CALIFORNIA COASTAL COMMISSION

REVISED FINDINGS ON CONSISTENCY DETERMINATION

Consistency Determination No.: **CD-003-13**

Project Description: 50-Year Coastal Storm Damage Reduction and Beach Nourishment Project

Exhibit A
Photos of Elevated Beach Profiles at Los Peñasquitos Lagoon Inlet
Beach Elevation Data at Torrey Pines State Beach - LIDAR

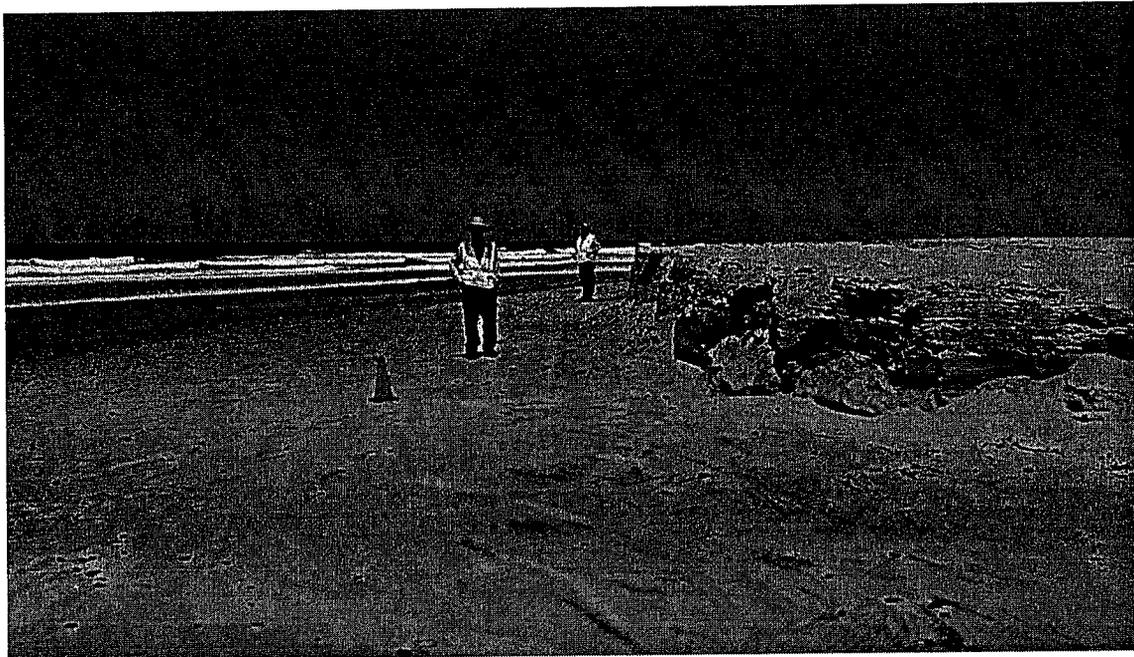
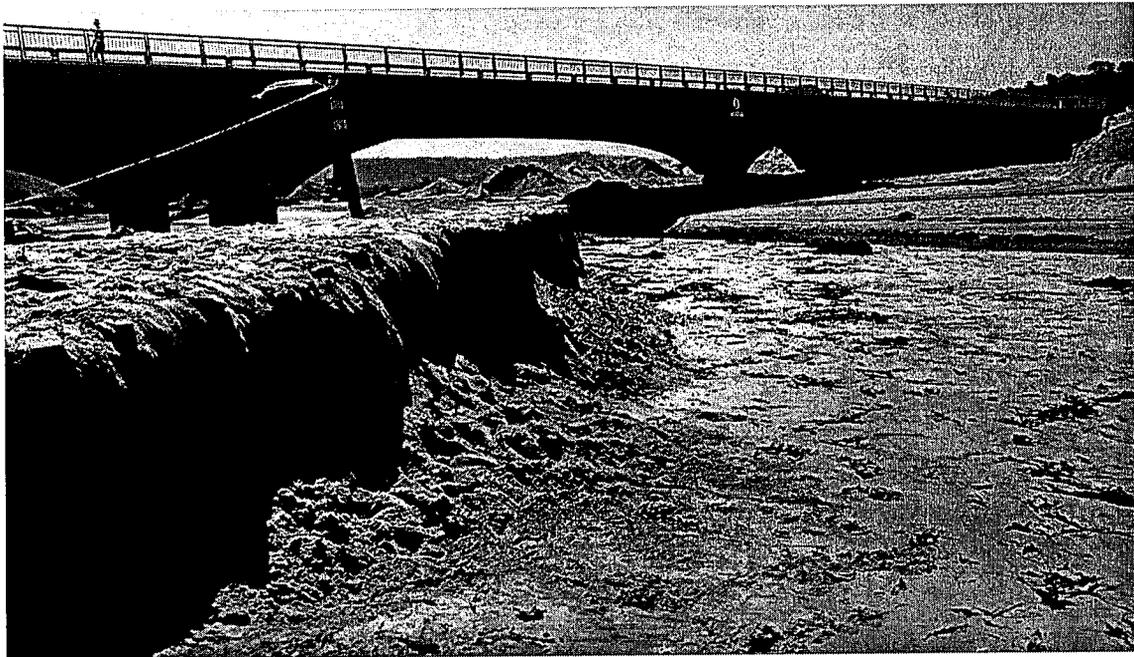
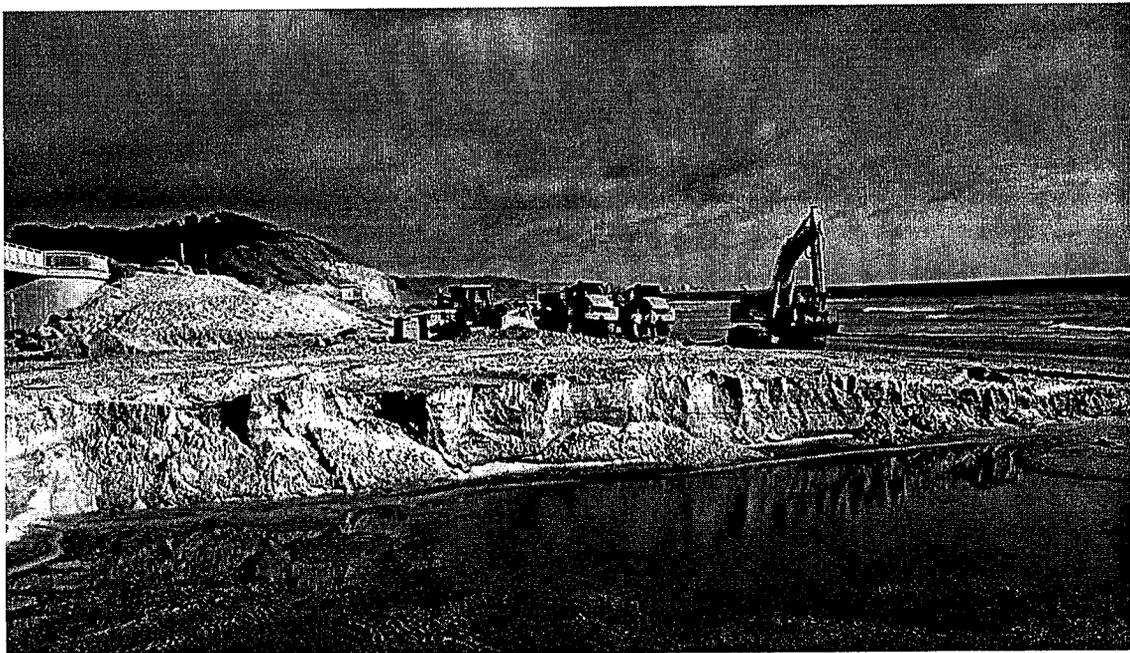
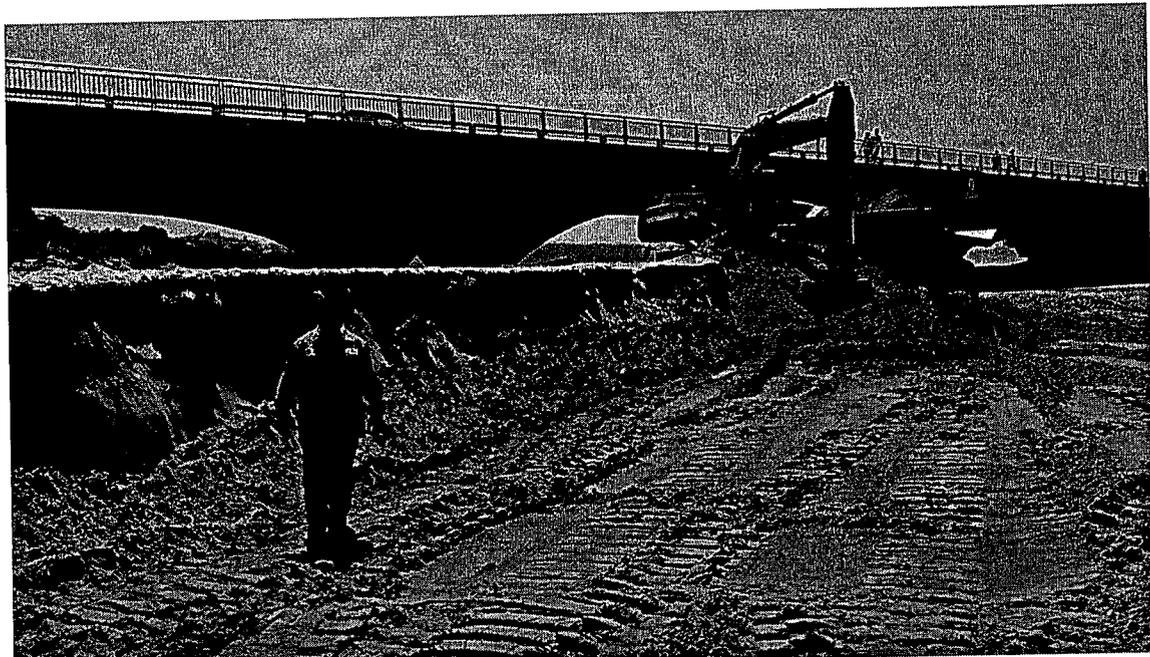
Figure 1. View of Beach Profile, Northern Edge of Los Peñasquitos Lagoon Inlet. May 14, 2013.

Figure 4. View of Beach Profile, Southern Edge of Los Peñasquitos Lagoon Inlet. June 12, 2013.
Approximately 3-6 feet of additional sand above the lagoon inlet waterline.

Figure 5. View of Beach Profile, Northern Edge of Los Peñasquitos Lagoon Inlet. June 17, 2013.
The inlet area had already been excavated multiple times prior to this photo.

Comparisons of Size & Abundance for "Trees" & "Weeds", as represented by stipple marks

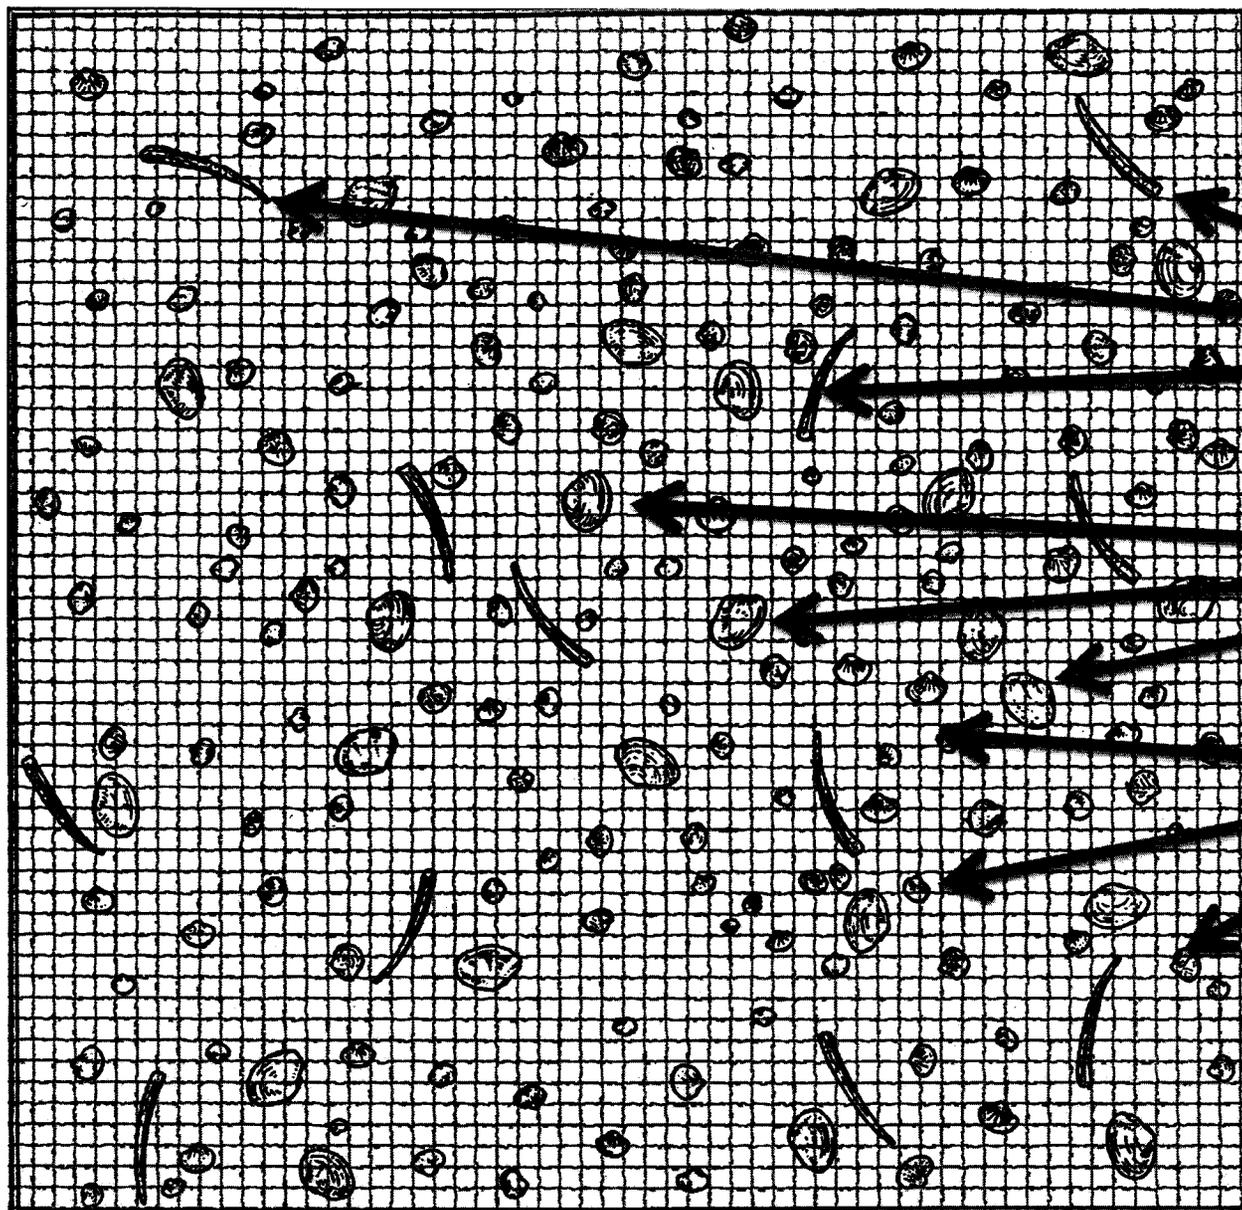
**Process produced flawed and inaccurate
estimates for ecological impacts of dredging
program and underestimated time required for
recovery of ecosystems in borrow sites.**
